The Village at Banfield Woods **Executive Summary of Submittal**

We are pleased to present you with a proposal for an Open Space Planned Unit Development (OSPUD) of 22 single-family dwelling units to be served by a private road which will be built to town standards.

47361.00 DR RCK FB
CK JUM CADFILE
DETAILS C-39

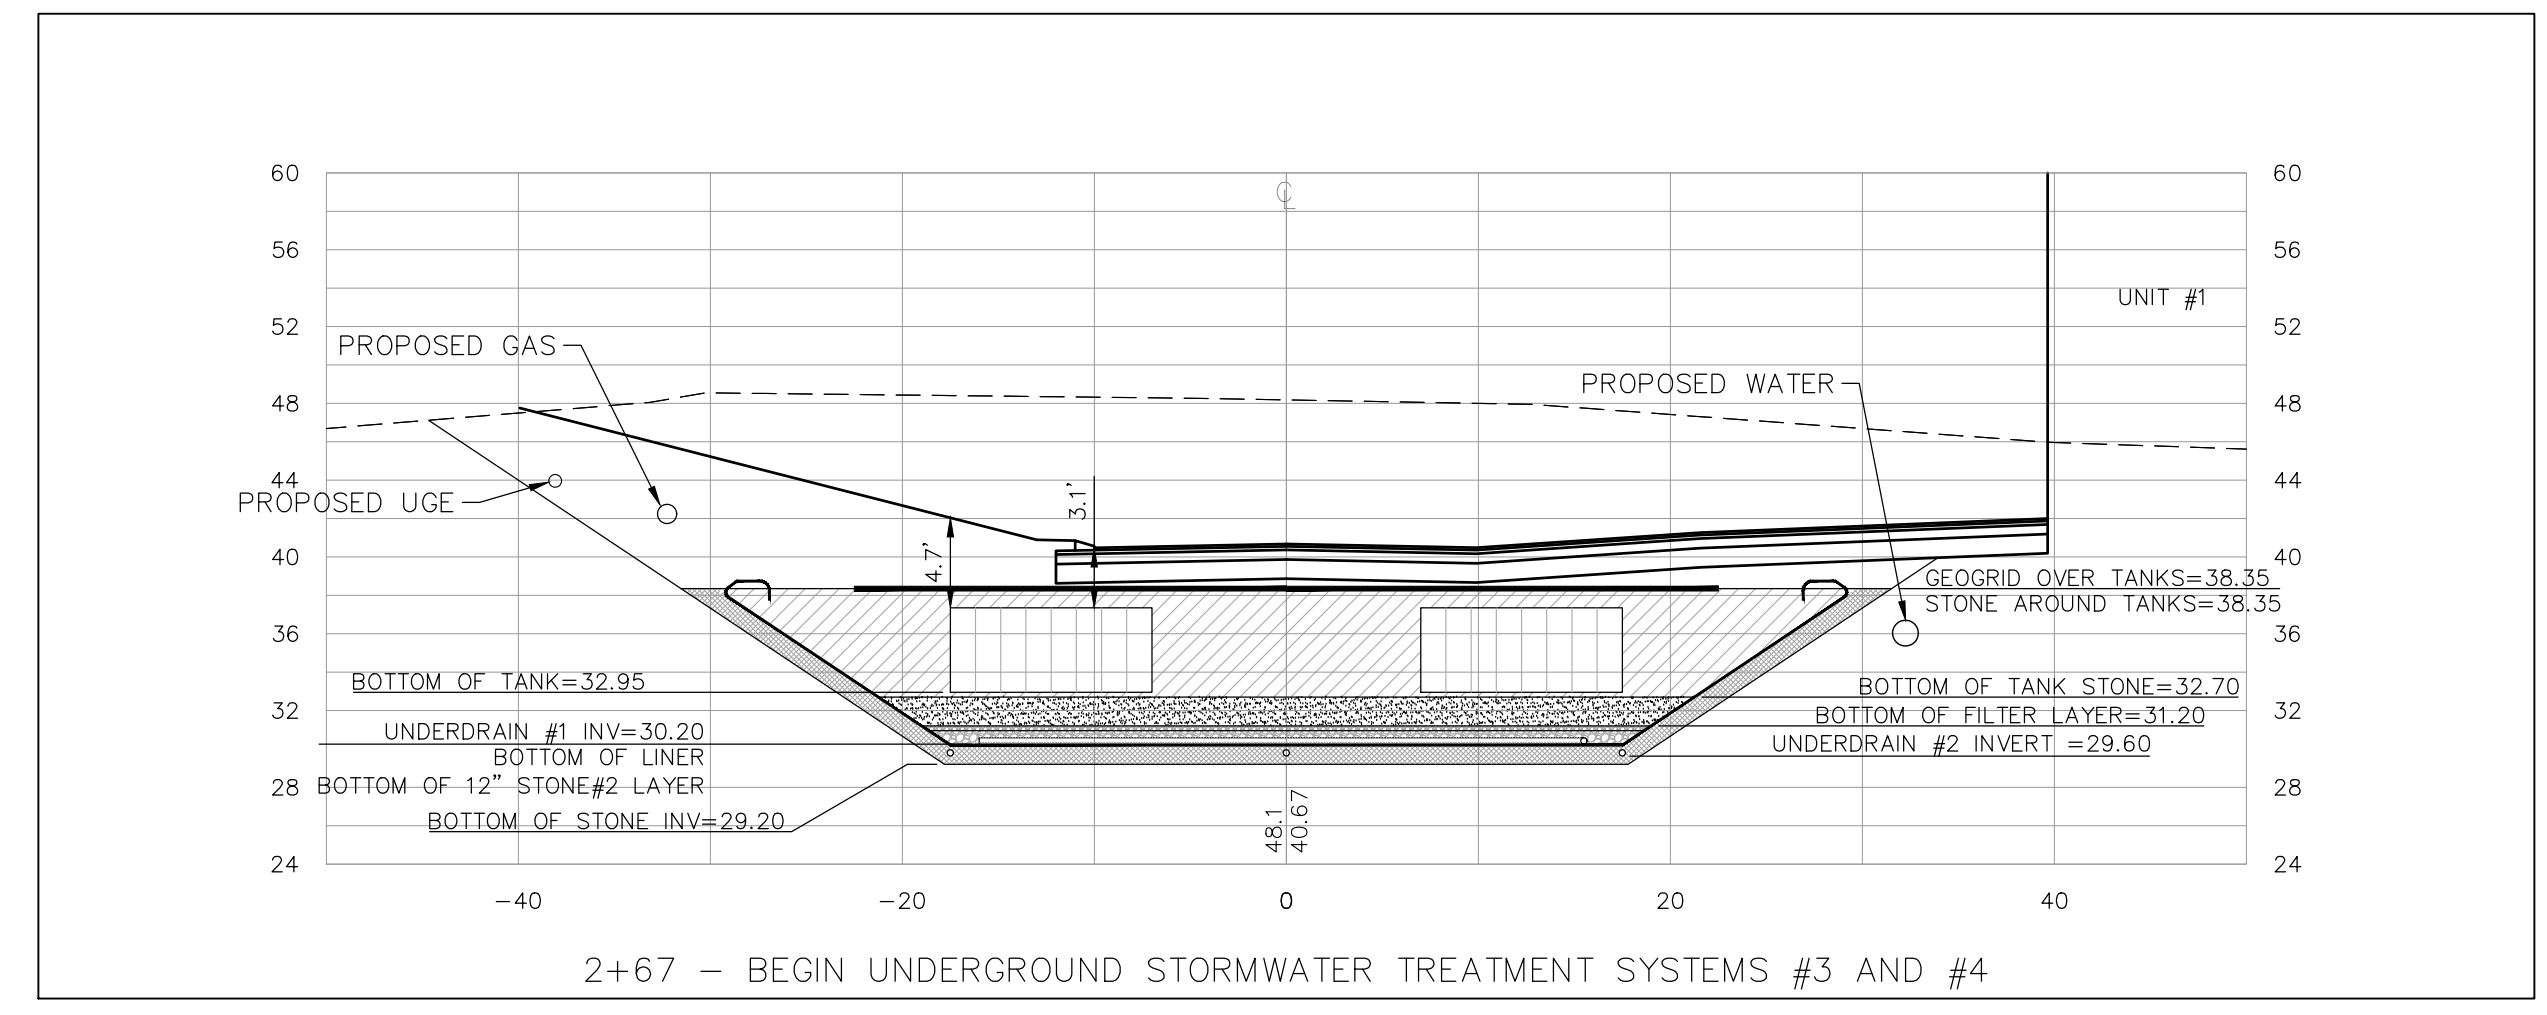
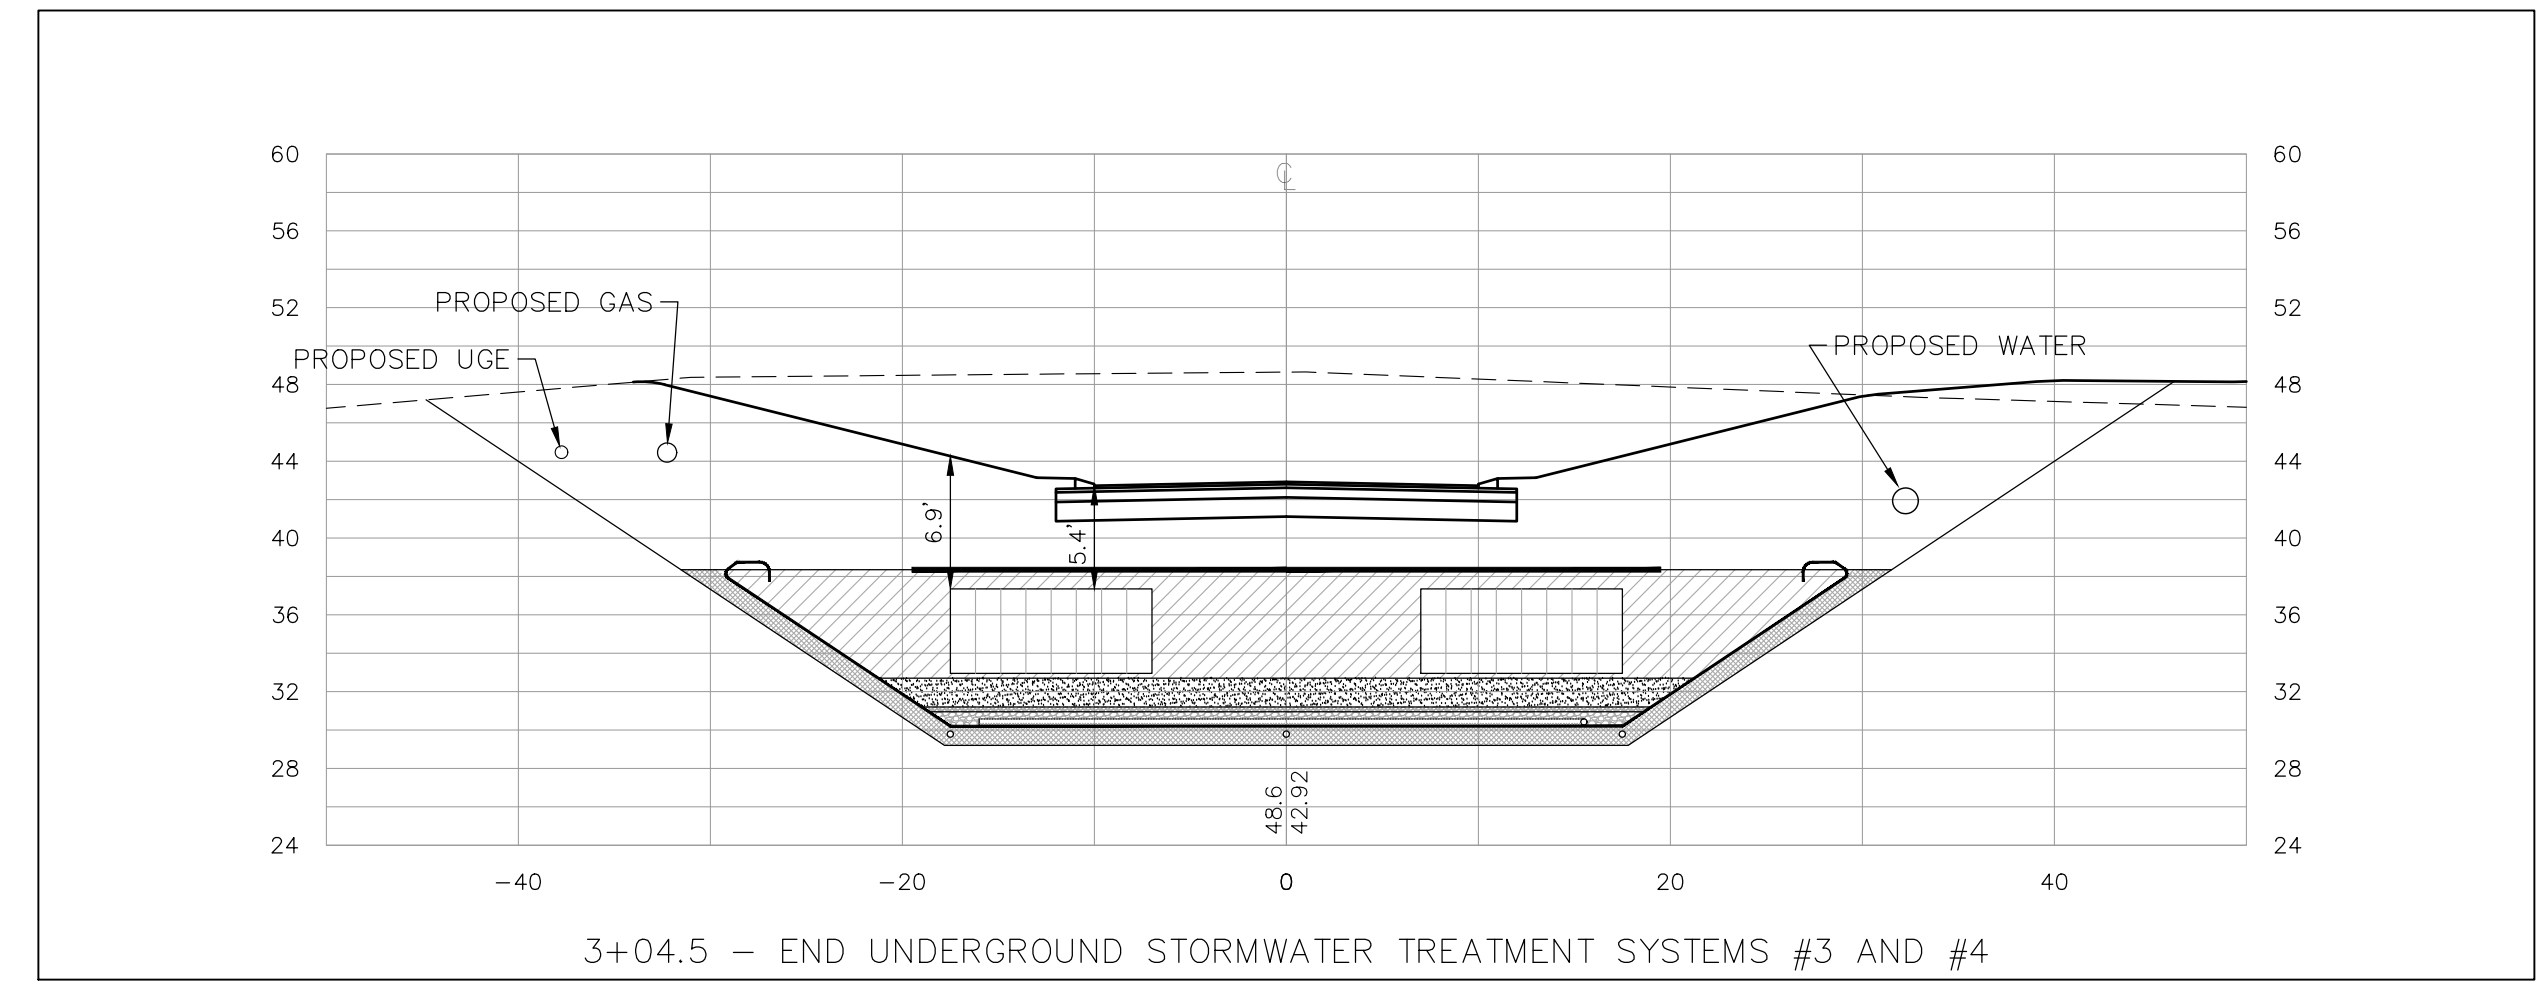
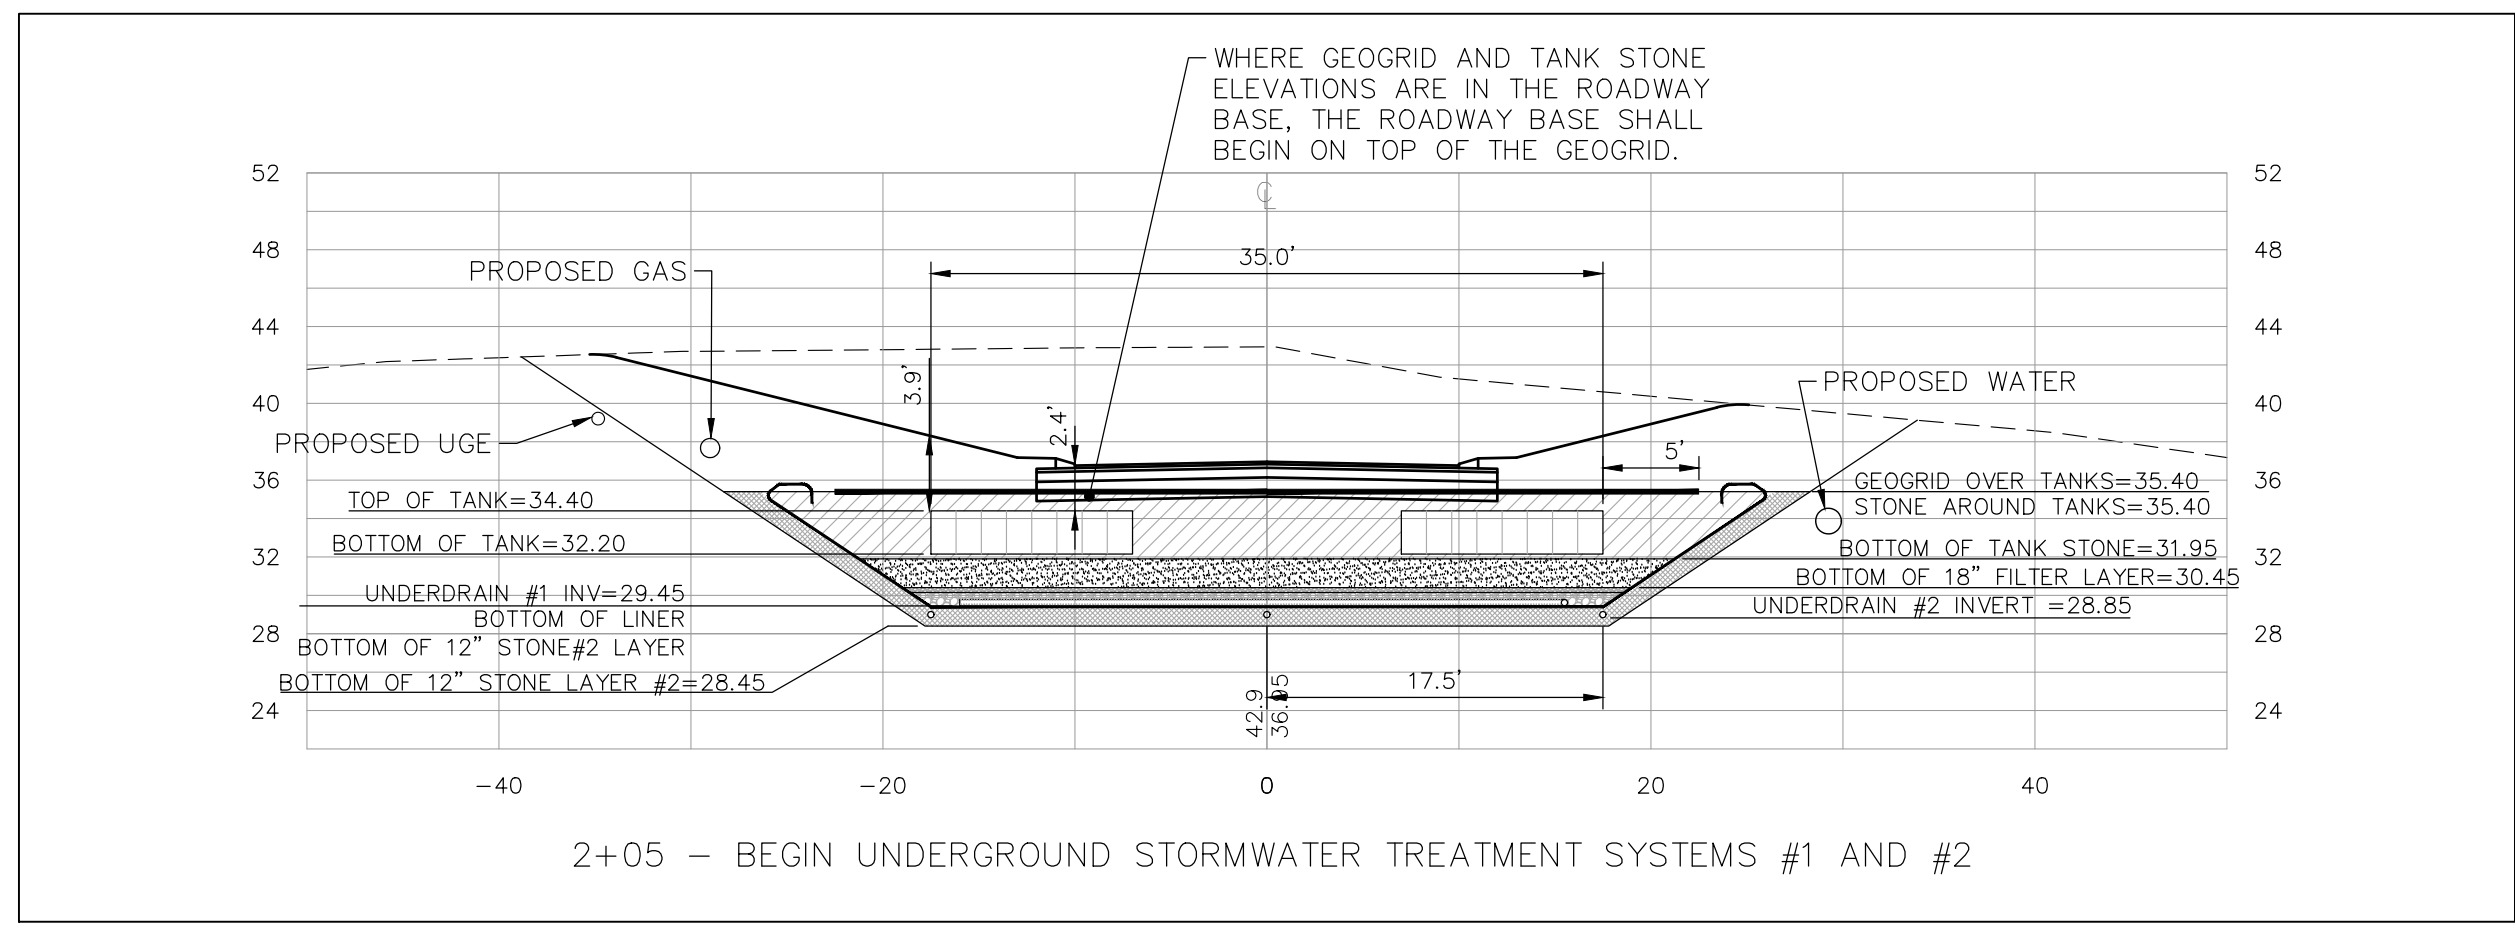
capabilities situated directly beneath each proposed R-Tank installation. As shown on Sheet C-39 of the site plan, stormwater tributary to the planned R-Tank installations is to be “filtered” through an 18 inch thickness of “filter soil mix” comprised of ASTM C-33 concrete sand, sandy loam and organic matter in a manner identical to a typical bio-retention system or rain-garden installation exposed to atmospheric conditions. Typical of most bio-retention systems, “filtered” stormwater then accumulates in successive 3 inch and 9 inch thicknesses of pea stone and crushed stone respectively, situated directly beneath the planned filter soil mix and atop an impermeable membrane, prior to discharge via a network of 4 inch diameter perforated pipes located at the base of the USTS.
